SUBJECT: Addendum No. 4

REFERENCE: Invitation To Bid (ITB) for the FAA Non-Standard Taxiways at William P. Hobby Airport; Solicitation No. H06-HOUTXY-2023-019; Project No. 770

PVC CONCRETE ENCASED DUCTBANK TYPICAL REINFORCEMENT
 NTS

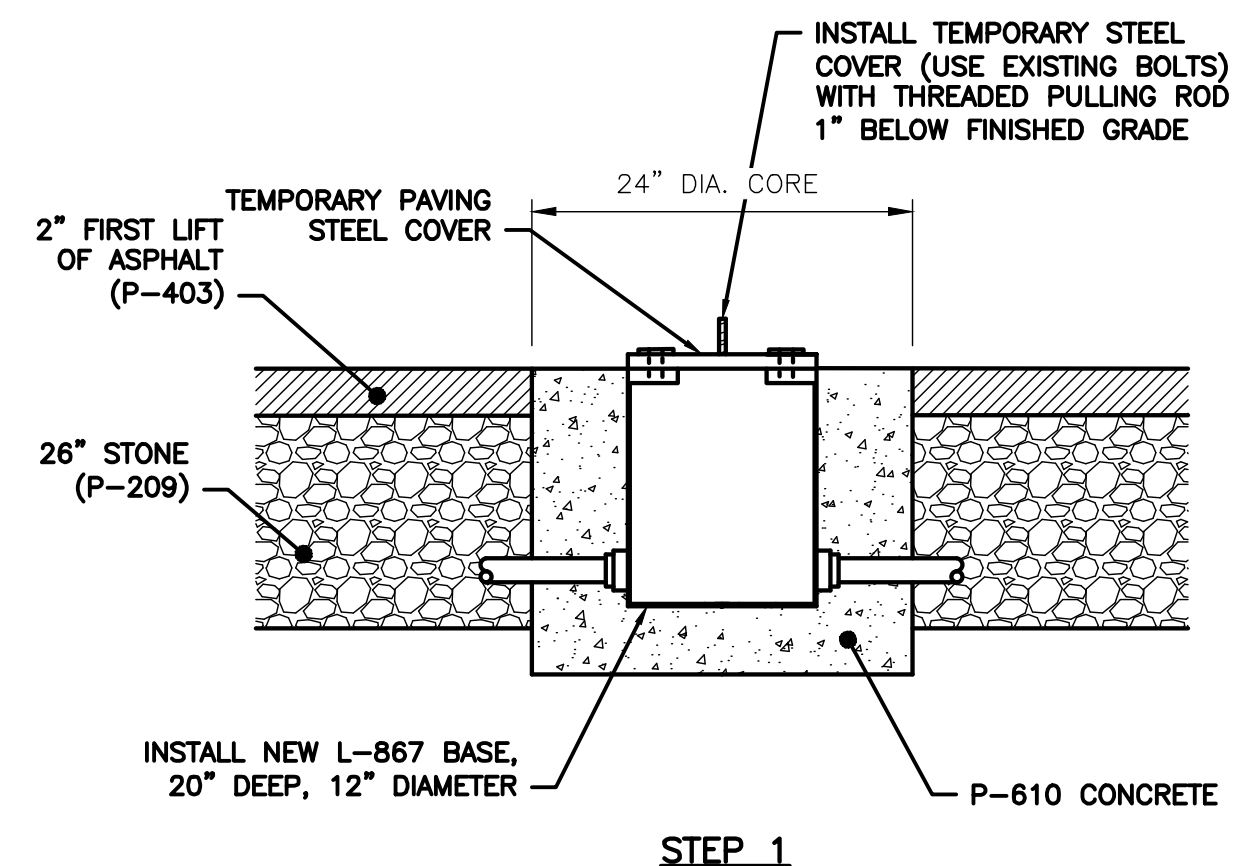
106. **Question:** See sheet EL510, detail 8. Is rebar reinforcement required for all ductbanks? If not, please specify which ductbanks this detail shall be applicable to.

Response: Reinforcing is required of any ductbanks that cross under full strength pavement and shall extend 5' beyond the edge of pavement per EL510. See updated General Note 5 on sheet E-001.
